**HISTORIC PRESERVATION REVIEW BOARD  
STAFF REPORT AND RECOMMENDATION**

Landmark/District: **Mount Pleasant Historic District** (x) Agenda  
Address: **1815 Lamont Street NW** ( ) Consent

Meeting Date: **November 20, 2014** (x) Alteration/addition  
Case Number: **15-004**

*Above: The row as seen from directly above (north is up).*

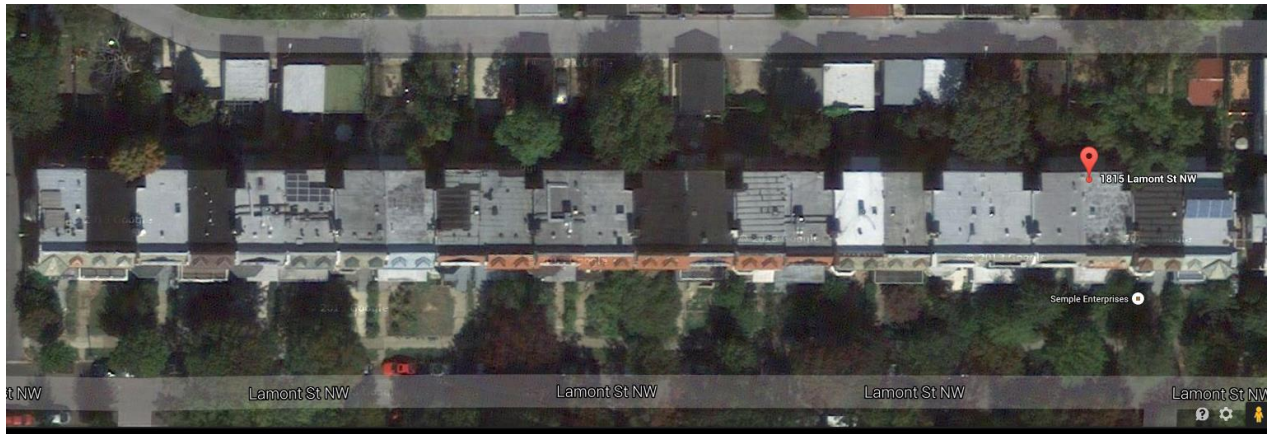
The literally larger question is the size of the addition relative to the main block and the rest of the row. There are no such additions yet on the row, but it would be well to develop an idea of what solutions may be generalizable here, as it is too much to hope that no one else will wish to adapt other homes for more intensive use.

The coming three-story addition at 1855 Lamont will be slightly more than twenty feet deep in acknowledgement of its deeper lot. But that depth is added to the depth of the ell that is to be retained. On the other hand, that addition was designed to be a “dogleg” ell with a side court at least the width of a zoning-compliant side yard, so it should be similar in volume to this one.

Just comparing the addition to the main block, the new construction does not overwhelm it or look disproportionately large in relation. The changes in the exterior material help articulate it. It should also be noted that at some other properties on this row, a significant amount of the available volume is occupied by a garage, which is not the case here or at 1855 as they have no accessory structures.
